Greenpeace UK Submission to OPRED on Shell's Environmental Statement on Jackdaw

Offshore Petroleum Regulator for Environment and Decommissioning
Reference: ES/2022/001

Jackdaw Field Development Further Information, UK North Sea Limited, Environmental Statement

Jackdaw Field Development – Consultation Response – Ref. D/4260/2021

Figure 1: Projected global oil and gas production from existing (shaded grey) versus new (shaded pink) fields, compared to oil and gas consumption in 1.5°C scenarios. Source: Muttitt *et al* (2025), reproduced from IISD Navigating energy transitions 2022.

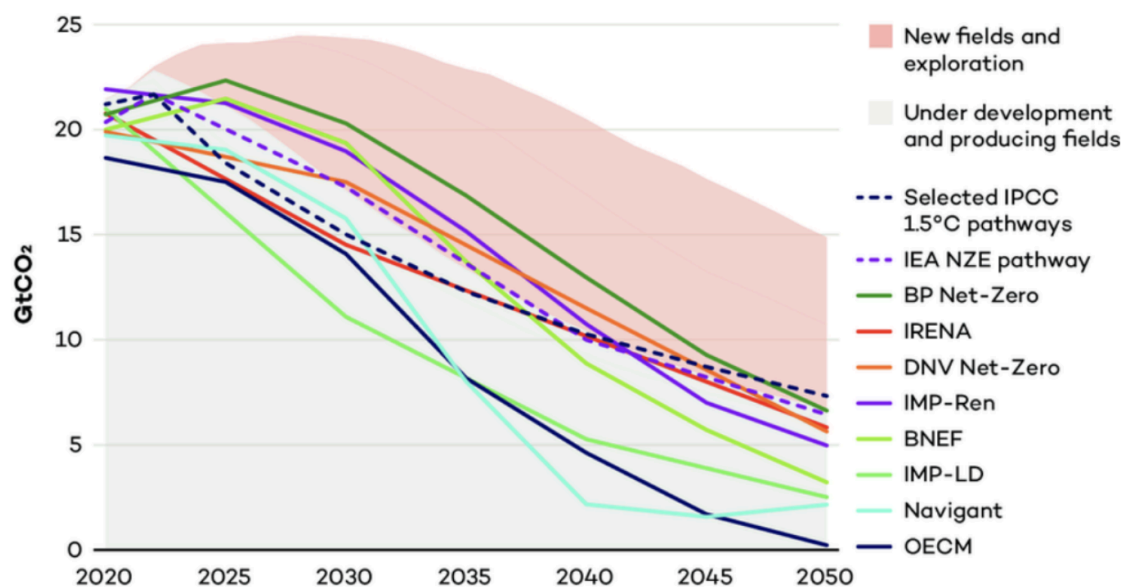
projected in the climate-pathway models (Figure 1). This would involve establishing a baseline of projected emissions from existing fields worldwide, with explicit assumptions about whether, how, and why any projects would produce less than their full reserves. This baseline should then be subtracted from emissions in a Paris-aligned pathway to determine the remaining ‘emissions space’ available for new projects. The project’s production (emissions) would then be evaluated as an incremental addition to this existing and committed supply.

20. This cumulative approach, consistent with methodologies adopted in the IEA World Energy Outlook (WEO) scenario analyses⁷, International Institute for Sustainable Development (IISD) report on navigating energy transitions,⁸ and University College London (UCL) report on climate implications of new oil and gas fields in the UK⁹, and peer-reviewed literature on establishing an accurate baseline¹⁰, would enable a meaningful assessment of whether the addition of the Jackdaw Project’s production is compatible with Paris-aligned pathways.

21. Consequently, the use of modelled global production volumes as the denominator in the analysis of the Further Information is methodologically inappropriate and it fails to produce a valid or cumulative assessment of significance. Global fossil fuel production data is available from providers such as Wood Mackenzie, Rystad, and IHS Markit. Peer-reviewed, credible estimates of committed emissions from fossil fuel production
